MEETING DATE: 5/02/05  
ITEM NO. 15

## COUNCIL AGENDA REPORT

SUBJECT: CONSIDER AN APPEAL OF A PLANNING COMMISSION DECISION DENYING AN APPLICATION TO CONSTRUCT A SINGLE FAMILY RESIDENCE ON PROPERTY ZONED HR-1. NO SIGNIFICANT ENVIRONMENTAL IMPACTS HAVE BEEN IDENTIFIED AND A MITIGATED NEGATIVE DECLARATION IS RECOMMENDED. PROPERTY LOCATION: **107 DRYSDALE DRIVE** PROPERTY OWNER/APPLICANT/APPELLANT: HOWELL & MCNEIL DEV. LLC. FILE #: S-05-16 AND ND-05-05

Attachments: Tree Inventory Table  
Site Map (Copy of Sheet C-2)

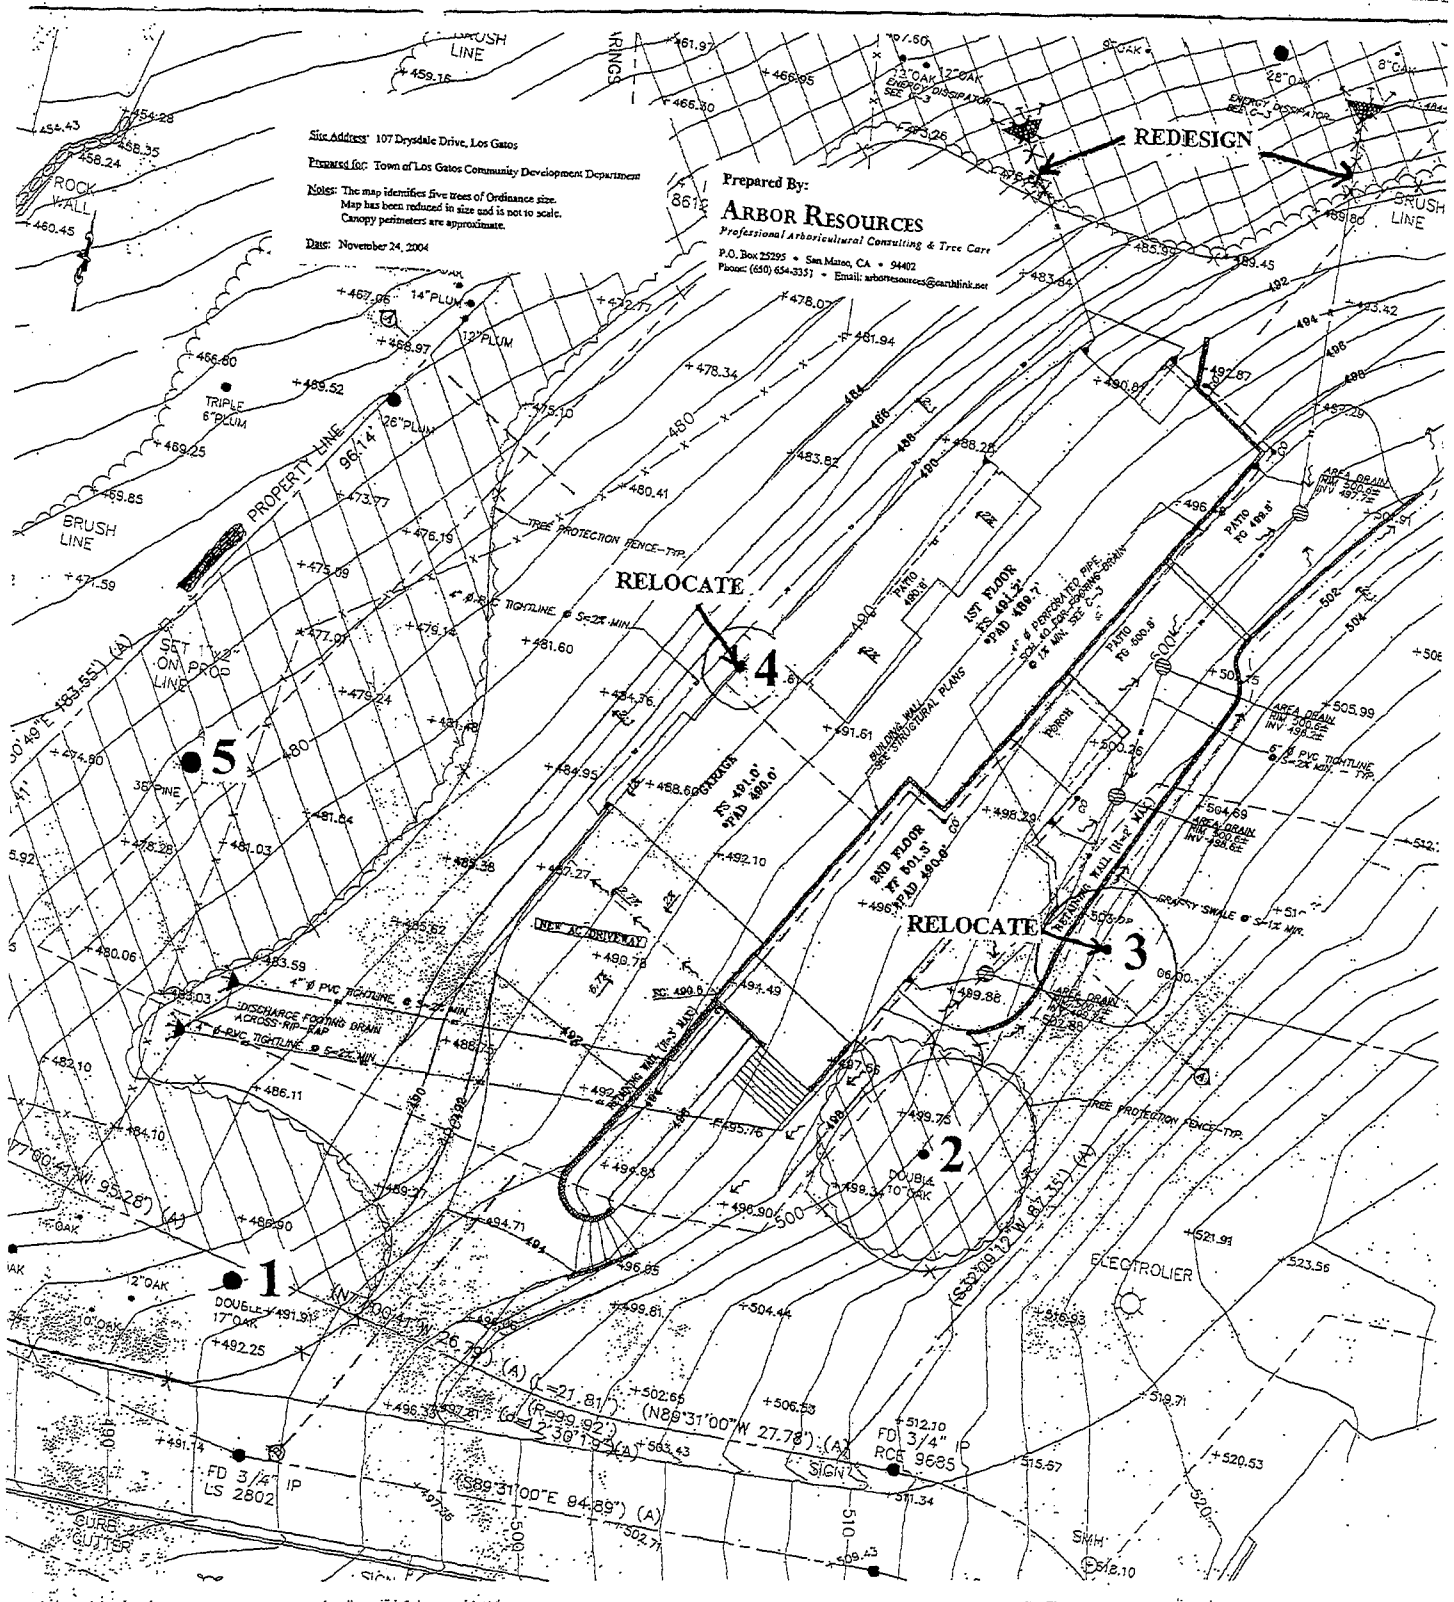
2. The two proposed storm drains and dissipaters mentioned in the previous section must be redesigned to be outside from beneath the canopies of trees (outside from the "brush line" shown on Sheet C-2).

5. Tree protective fencing must be installed precisely as shown on the attached map and established prior to any grading, surface scraping, construction or heavy equipment arriving on site; the location shown on Sheet C-2 is sufficient, provided some additional fencing is installed as shown along the road and northeast section (see attached map). Once established, the fencing must remain undisturbed and be maintained throughout the construction process; the dismantling of fencing must be approved by the Town before doing so. It must be comprised of five-foot high chain link mounted on two-inch diameter, galvanized steel posts, driven 18 inches into the ground and spaced no more than 10 feet apart.

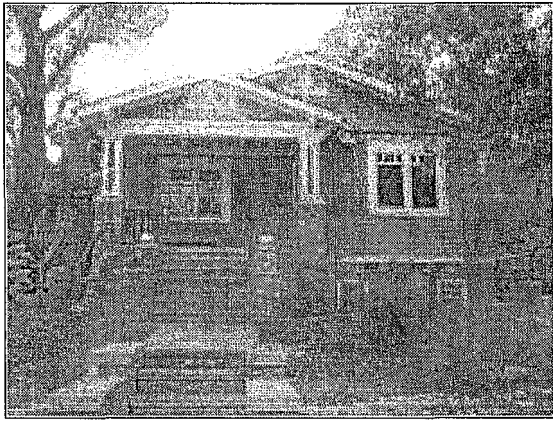
1. Strengthen the wood trim at the porch floor edge.
2. Add stone side walls to the steps to tie the stair into the porch stone base and the site.
3. Add wood caps to the side walls to match the trim at the porch edge. Alternatively, stone caps could be used.
4. Carry the stone around onto the retaining wall that edges the driveway and extends up to the walk to the porch. This may have been the intent in any case, but I couldn't tell from the drawings. This would further integrate the stone wall and porch into the site.

I don't have a directly comparable photo to demonstrate this approach, but the Grabill Residence in Los Gatos, shown in the photo below, is similar in terms of the stair side walls and relating the stone walls of the porch with others at the sidewalk entry. This photo shows stone for the stair risers and treads. I don't think that is necessary in this case. Wood risers and treads would probably be best.
